BEFORE THE MERIDIAN CITY COUNCIL

CASE NO. FP-2026-0026

**ORDER OF CONDITIONAL
APPROVAL OF FINAL PLAT**

SUBJECT: Springday Subdivision No. 2
FP-2026-0026

FINAL PLAT OF SPRINGDAY SUBDIVISION NO. 2

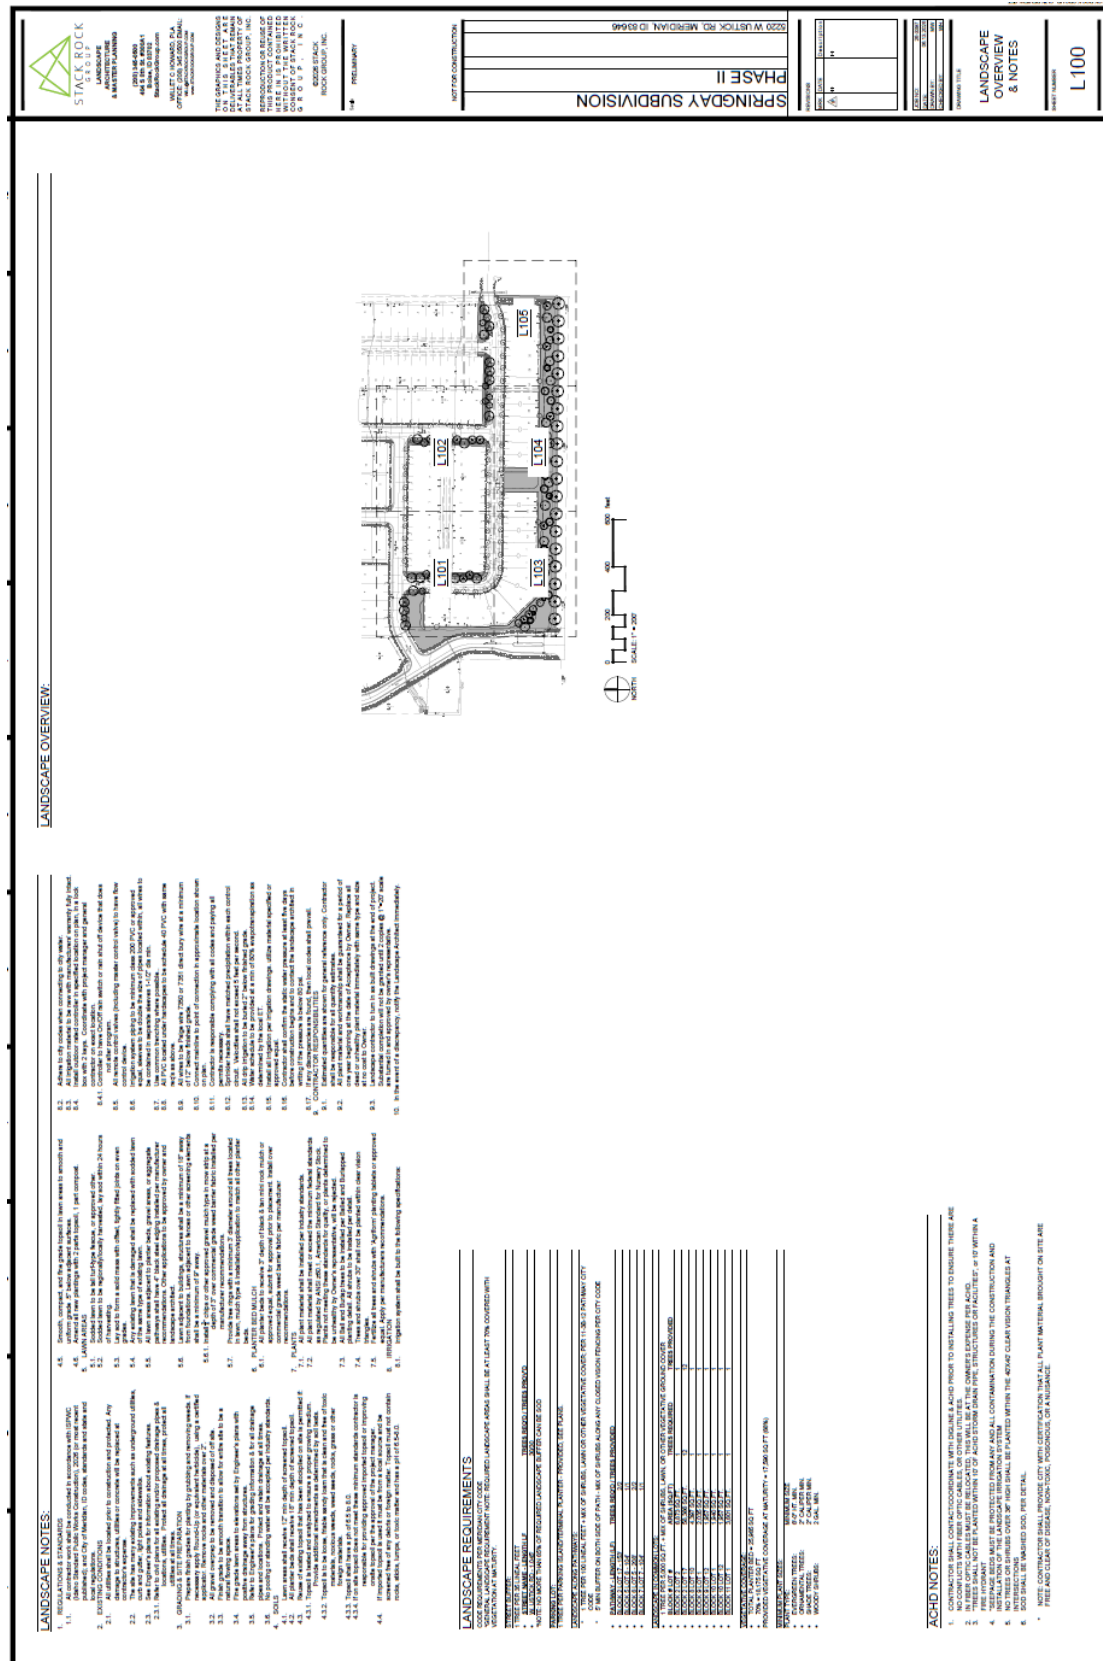
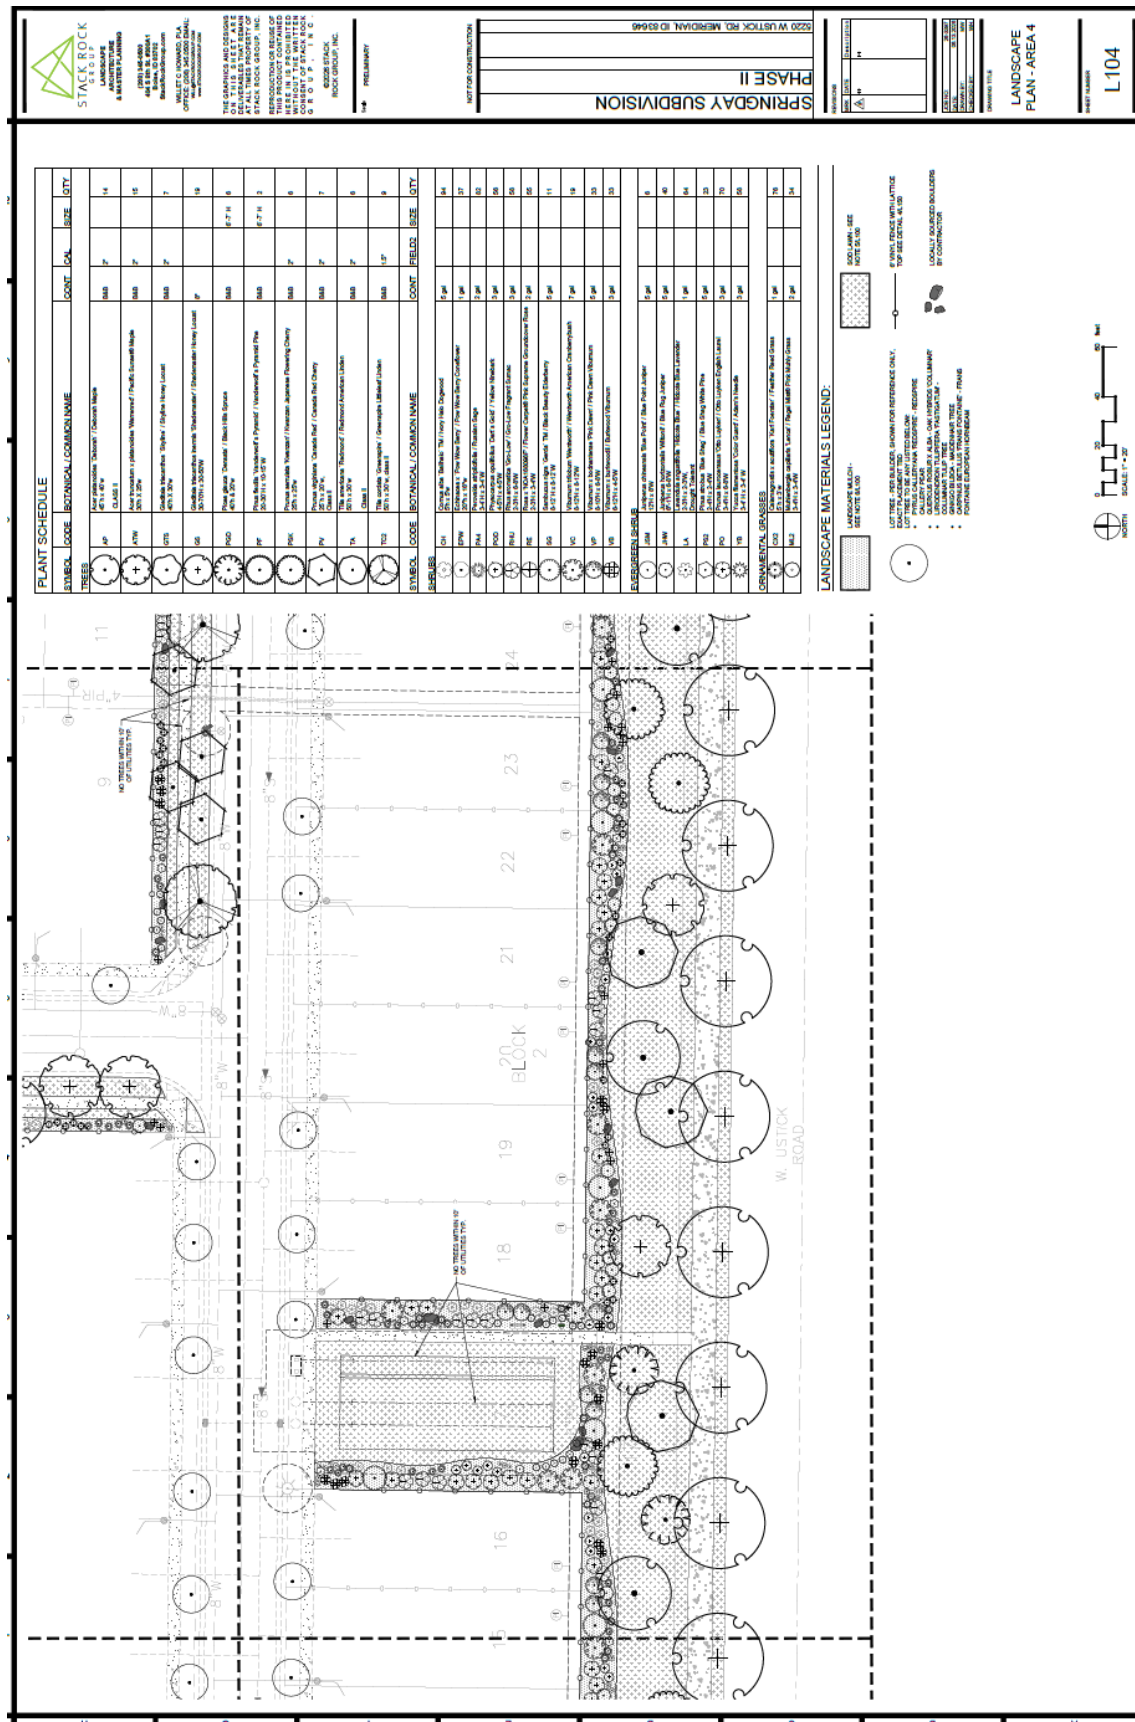
3. Prior to submittal for the City Engineer's signature, have the Certificate of Owners and the accompanying acknowledgement signed and notarized.
4. The final plat prepared by Focus Engineering and Surveying, LLC, dated: 07/29/2026, included in Section V.B shall be revised as follows:

- a. In the Legend, include the recorded instrument number of the ACHD permanent easement.
 - b. Include the CP&F numbers on Sheet 1 at the northwest and southwest corners of the site.

- c. Note #11: Include the recorded instrument number of the ACHD temporary license agreement.

A copy of the revised plat shall be submitted with the Final Plat Mylar application for City Engineer signature.
